April 17, 2014

**Subject: Response to DEQ Comments
Annual 2013 Groundwater Monitoring and LNAPL Removal Report
Port of Portland Terminal 4 Slip 3**

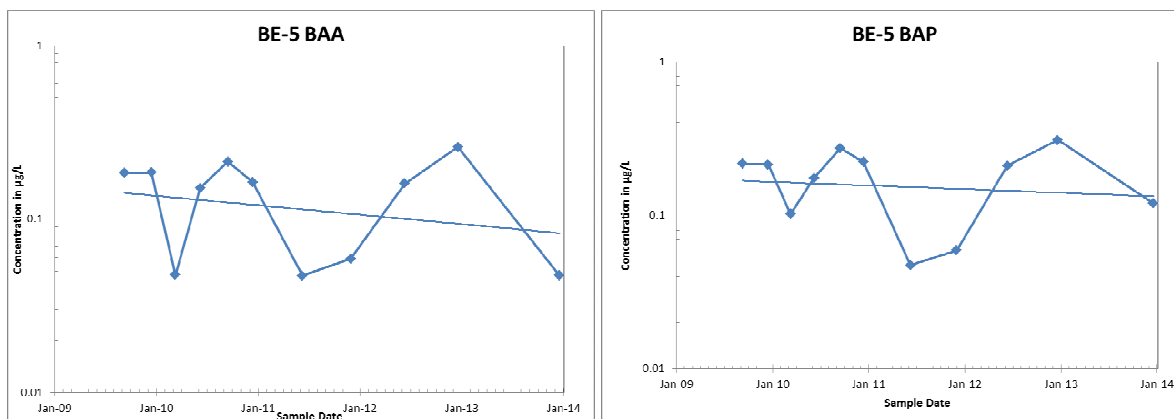
2. *Section 4.5 Conclusions and Recommendations, page 7, Item No. 4. Concentrations of BAA and BAP in sentinel monitoring wells BE-5 and BE-3 have not been stable or declining for at least three years as shown in the chemical concentration trend plots in Appendix D.*

The statistical analysis of BAA and BAP in BE-3 and BE-5 was conducted using the data from June 2005 through December 2013. The results show a statistically significant downward trend in the historical data sets for both BAA and BAP in well BE-3 (with confidence values of 99% or greater) and a stable trend for both BAA and BAP in well BE-5 (trend confidence values are less than 90 percent, and COV values are less than 1).

If the data set is abridged to the last three years (December 2010 through December 2013), the Mann Kendall evaluation cannot be completed due to an insufficient number of data points. Straight-line regressions through this three year data set (as calculated by the Excel regression function; presented below) indicate slightly positive slopes on the order of 0.01 to 0.03 µg/L per year. These slopes are essentially flat and represent conditions near the

detection limit with interspersed detections and non-detects. These results are characteristic of a stable condition. The compliance criteria have been met given the stable or declining trend for a continuous period of at least three years.

Well HC-5

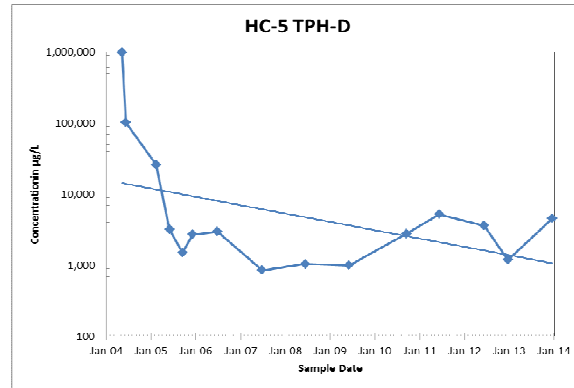
3. In addition, the concentration of diesel-range organics have not been stable or declining for at least three years in monitoring well HC-5 as shown in the chemical concentration trend plots in Appendix D. These data indicate the groundwater sampling program should not be terminated as the report recommends.

Response. A Mann-Kendall statistical evaluation was completed on the TPH data from well HC-5 (as described above). The results of the statistical analysis show no statistically significant concentration trend (the trend confidence value is less than 90%). A straight-line regression of the data set (shown in the plot included below) indicates a notable downward tendency in the data (an average decrease of 1,500 µg/L/year).

If the data set is abridged to the last three years (September 2010 through December 2013), the Mann Kendall evaluation cannot be completed due to an insufficient number of data points. A straight-line regression calculated through this three year period data set (Excel

regression function; presented below) indicates a negative slope (12 µg/L per year). These results are characteristic of a stable or decreasing condition. The compliance criteria have been met given the stable or declining trend for a continuous period of at least three years.

Revised Annual 2013 Groundwater Monitoring and LNAPL Removal Report - Appendix C

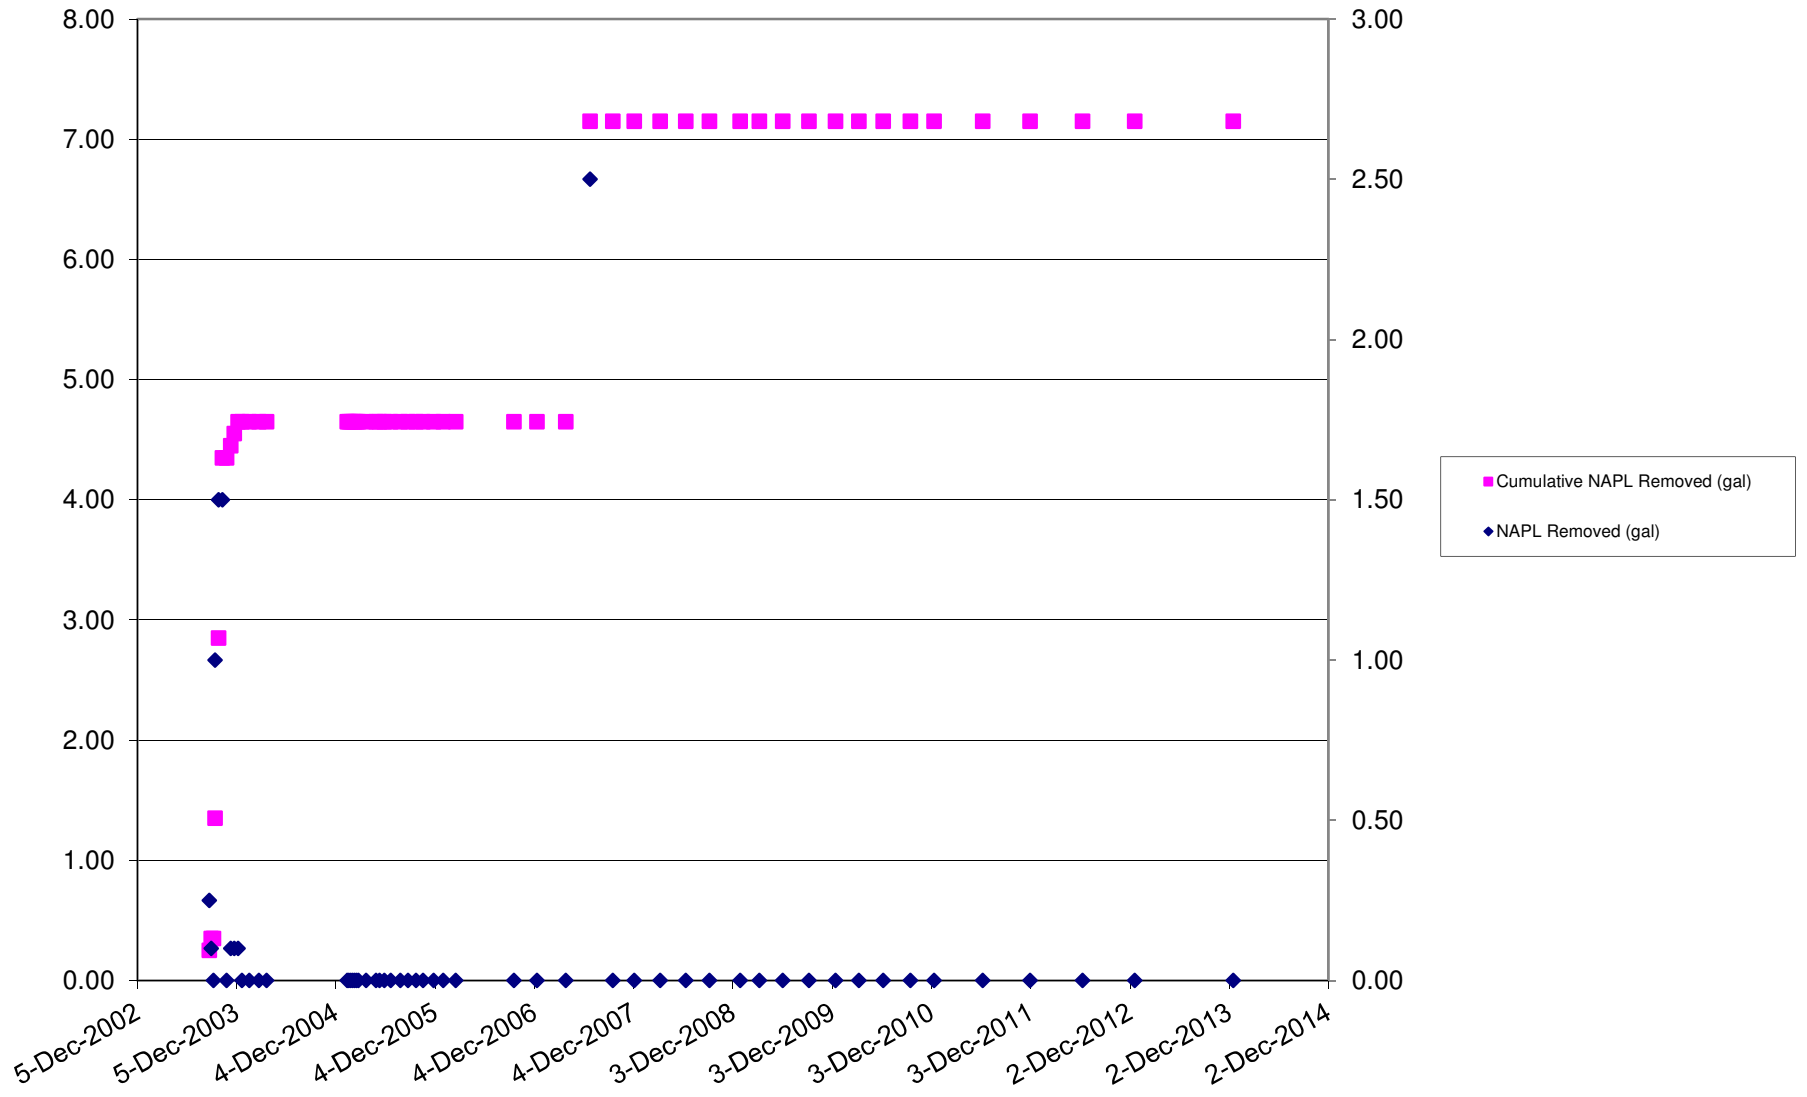
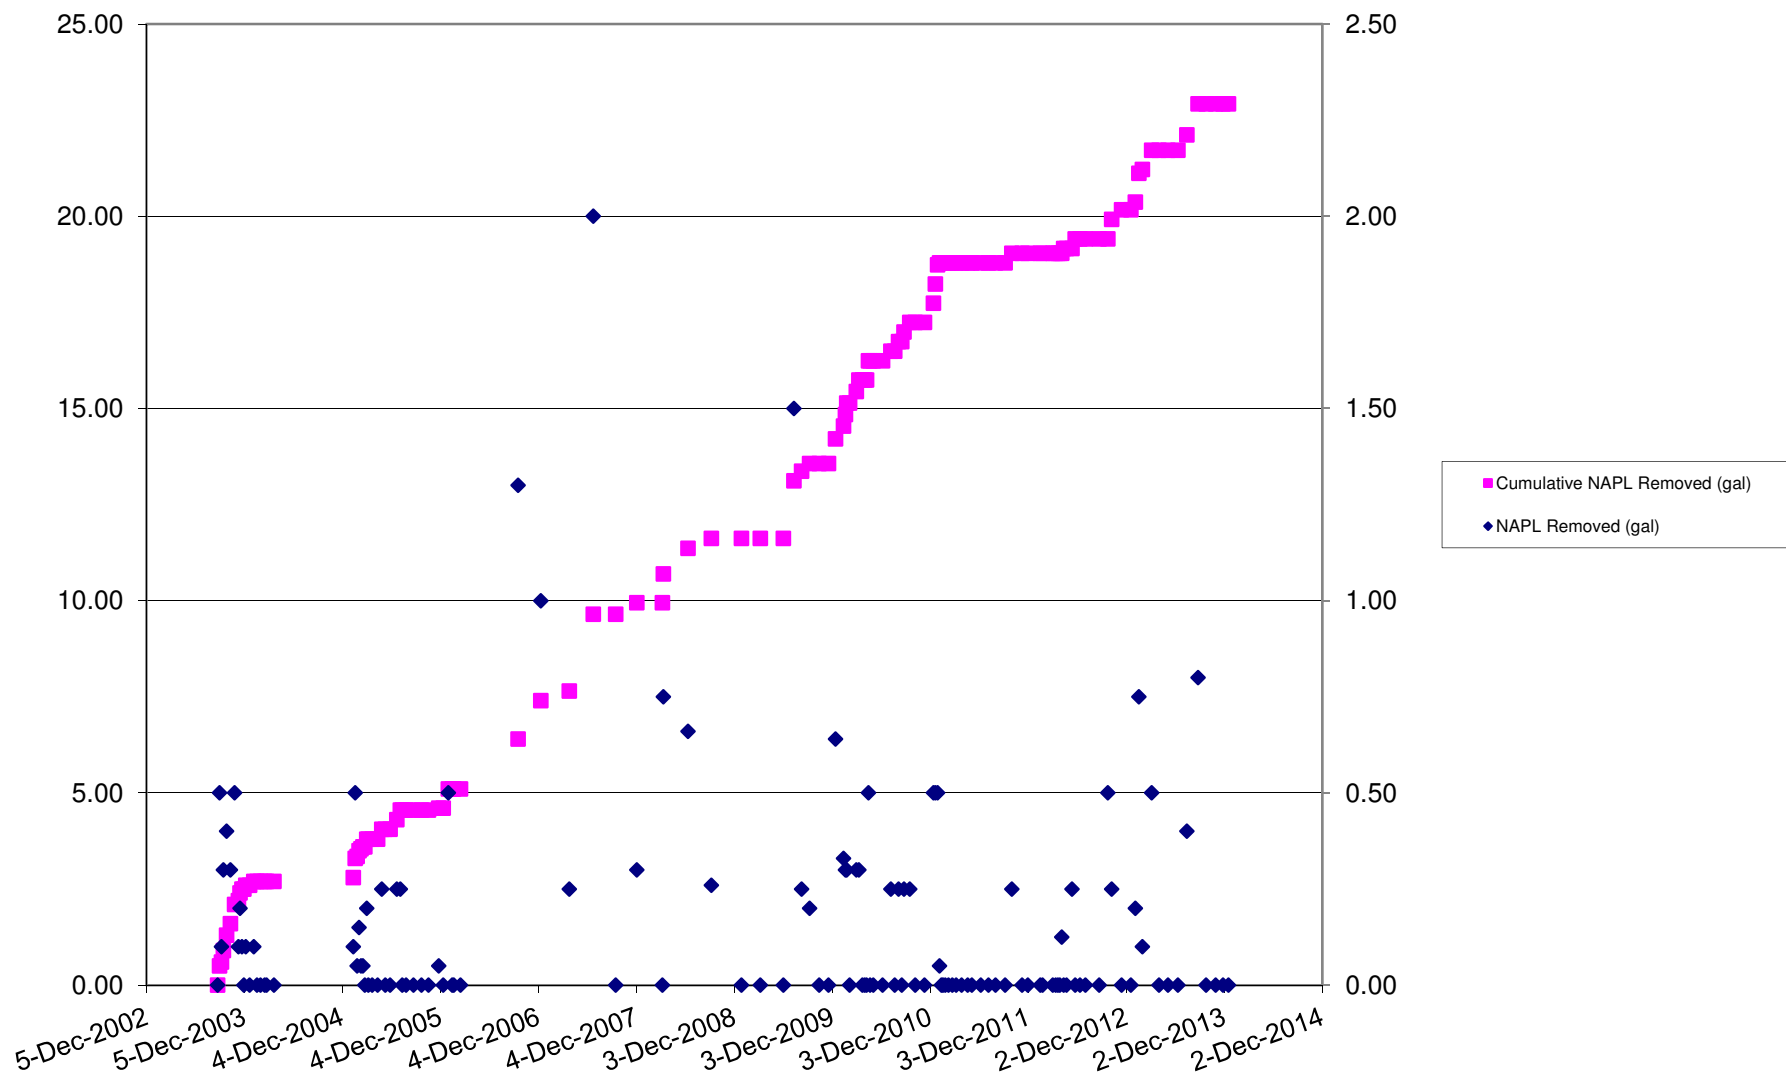
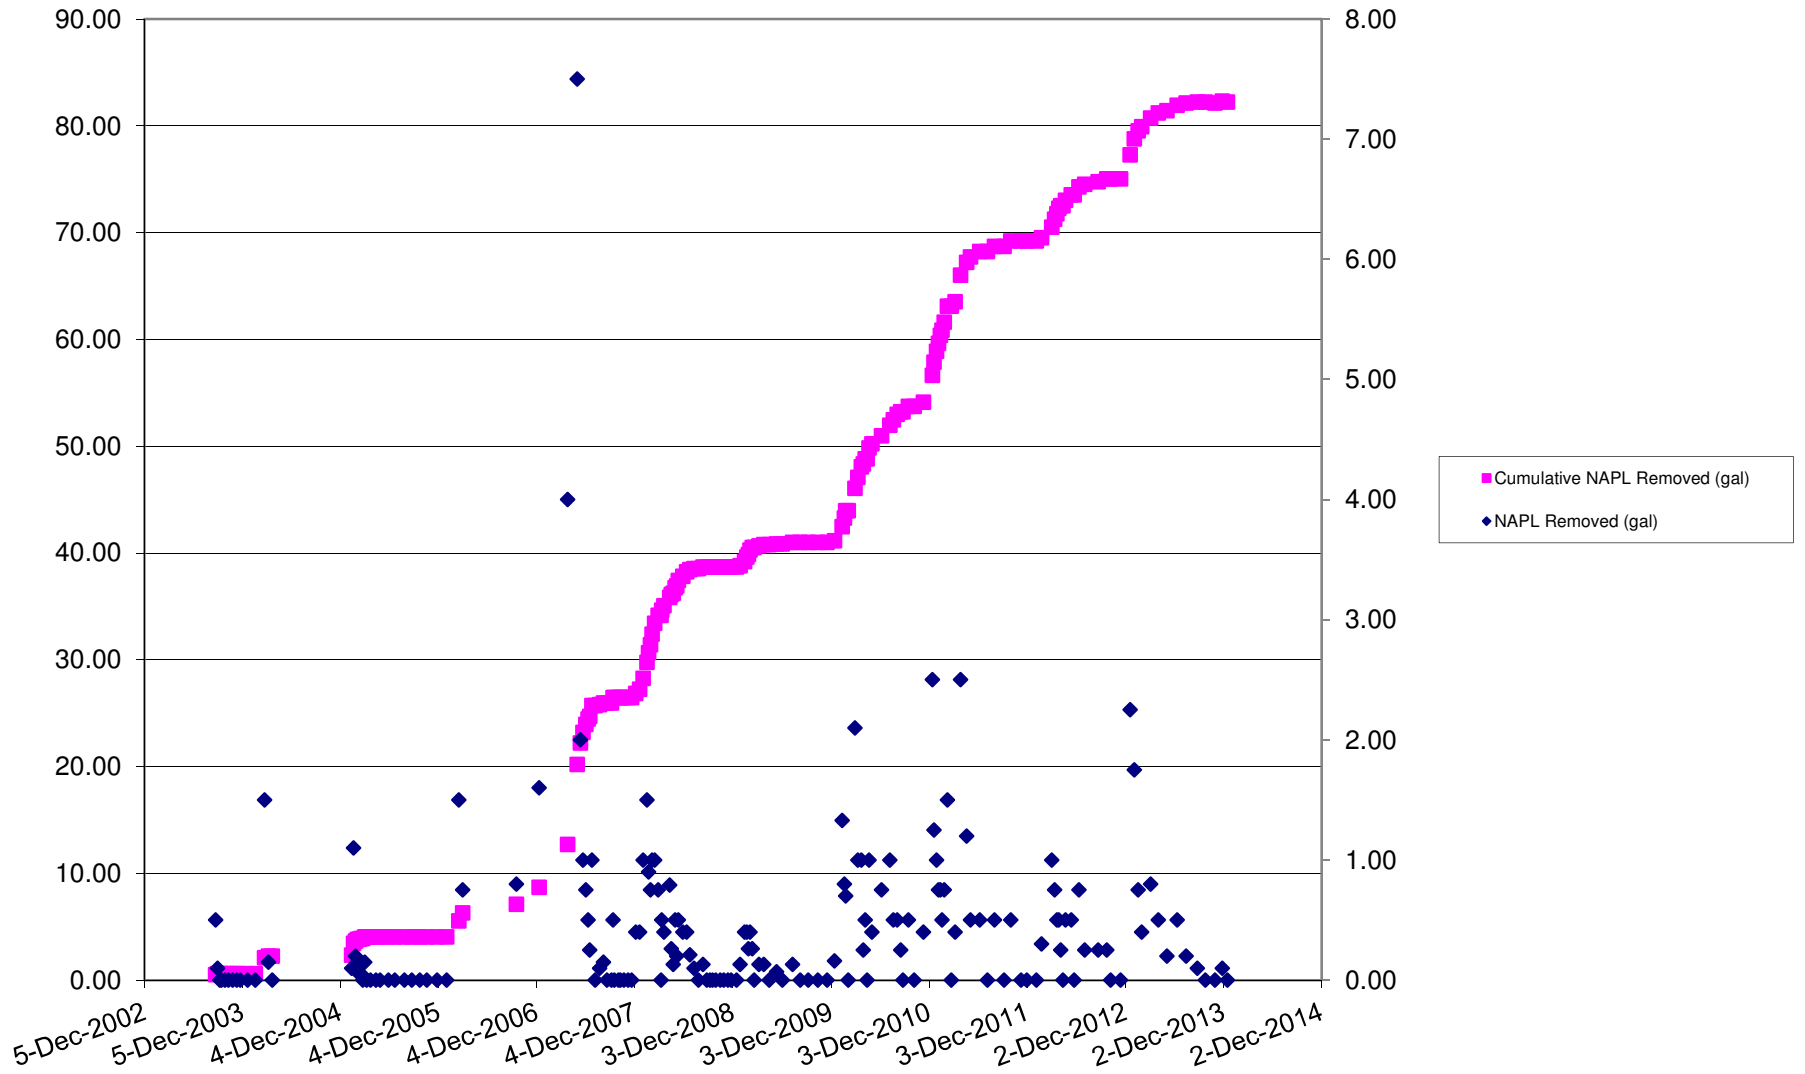
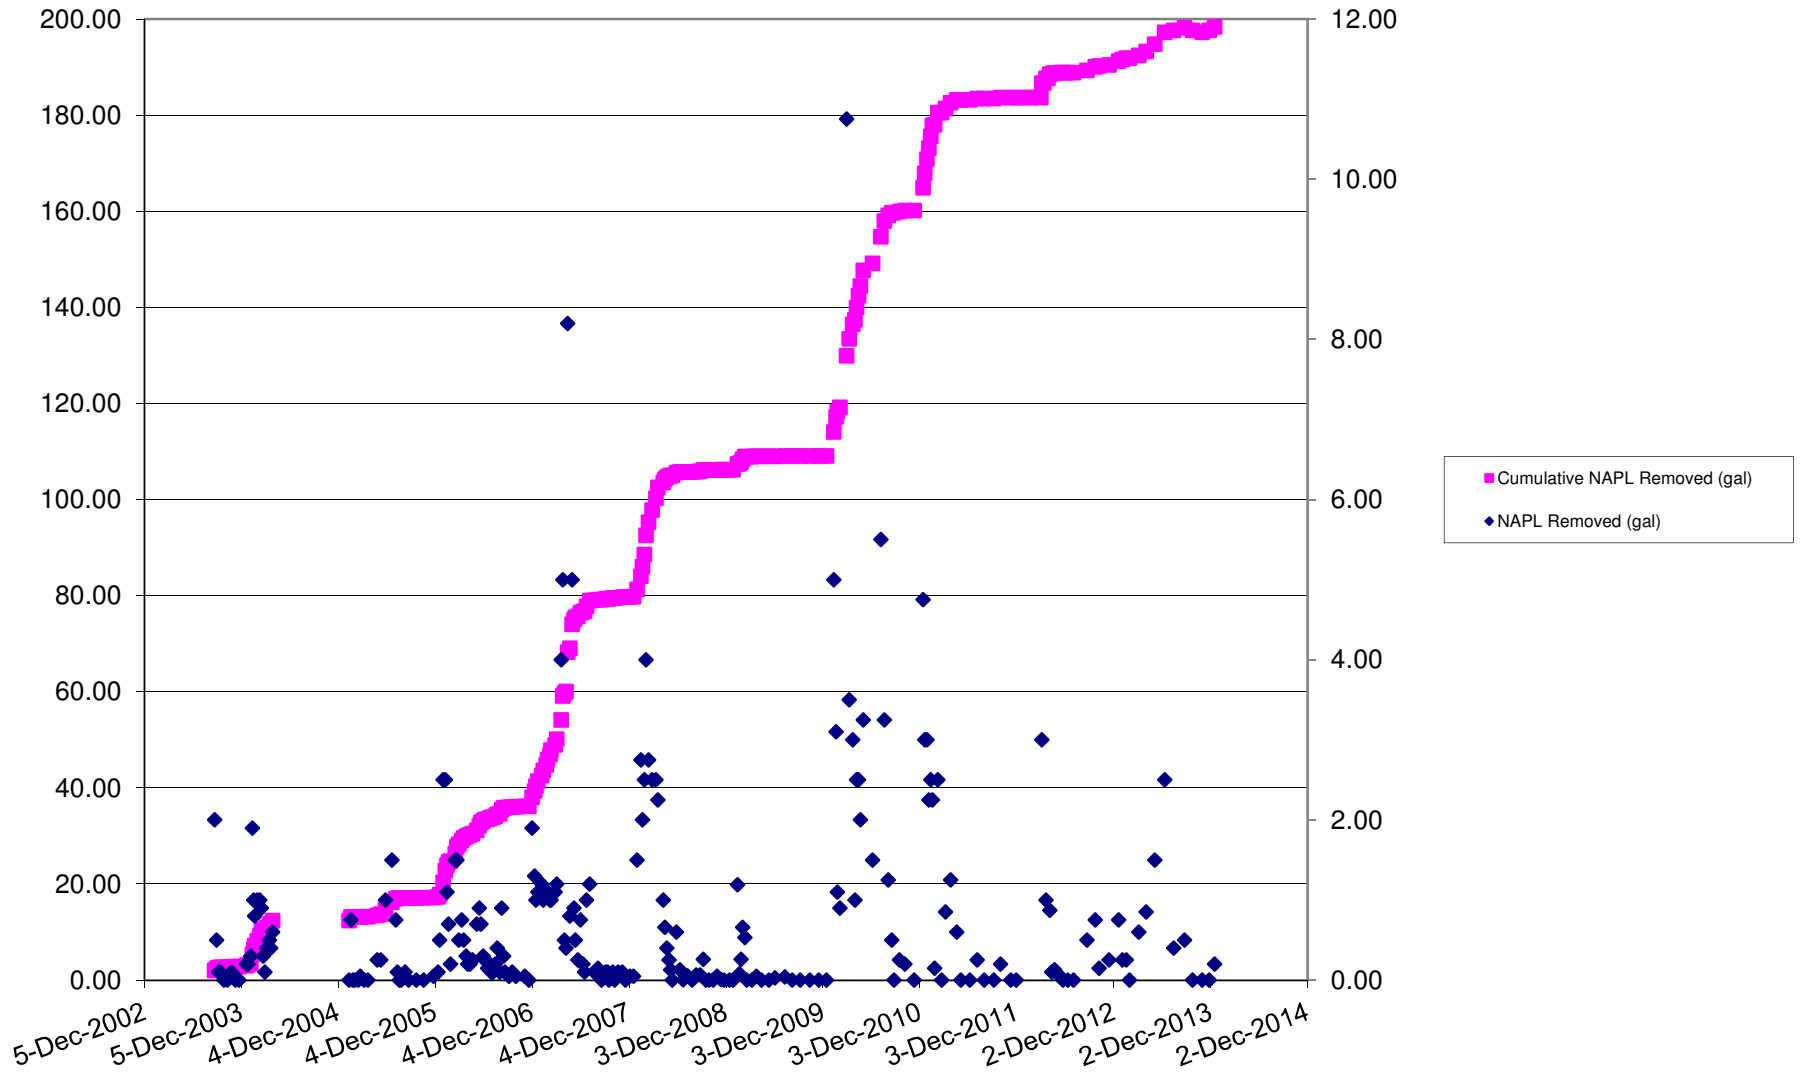
5. *Appendix C, LNAPL Thickness and Recovery Trend Plots. The scale for "NAPL Removed (gal)" on the graphs for all monitoring wells included in Appendix C should be revised so that any downward trend of recoverable NAPL can be visualized.*

Response. The plots in Appendix C have been modified to show the LNAPL removed for individual events on an expanded scale secondary y-axis.
